REMARKS

The drawings are objected to because the Examiner indicates that the amendment of 3 February 2005 described corrections to the drawings, but the office received no actual corrected drawings with the amendment.

FIG.2

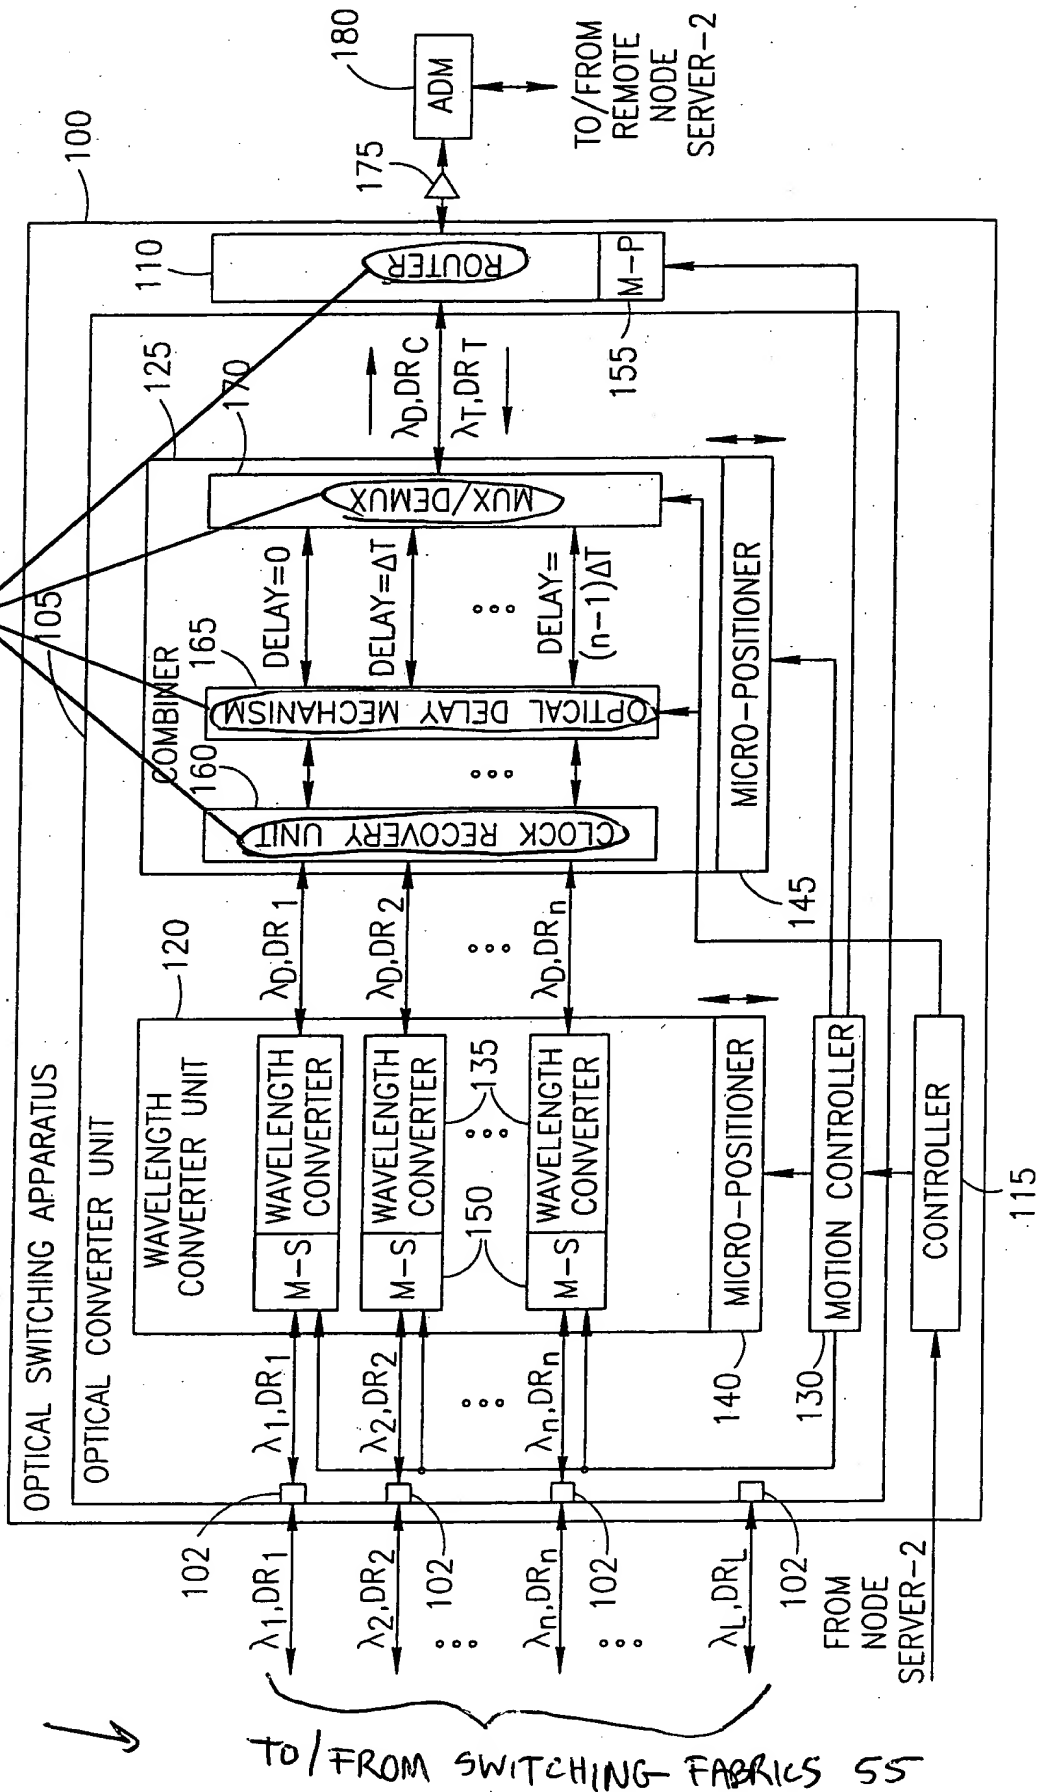
APPEARANCE
OF WORDS
CHANGED

LINK TO
ELEMENT 55
ADDED

FIG.3

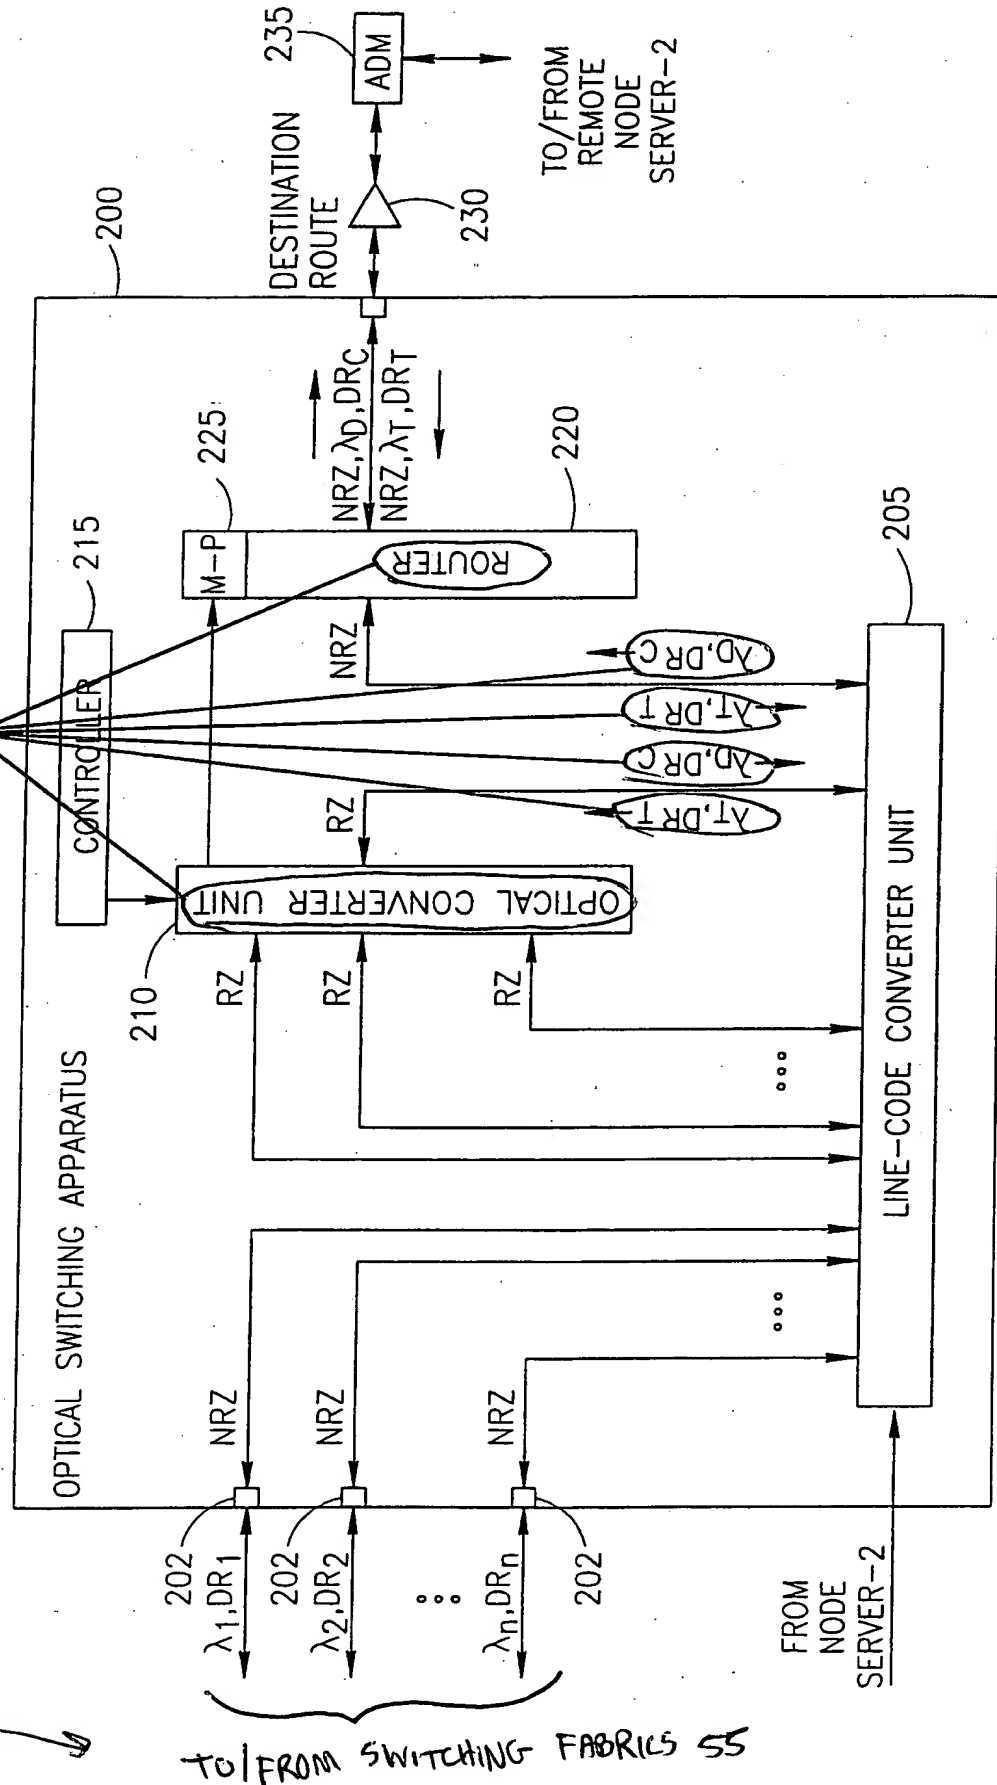
APPEARANCE
OF WORDS
CHANGED

LINK TO
ELEMENT 55
ADDED
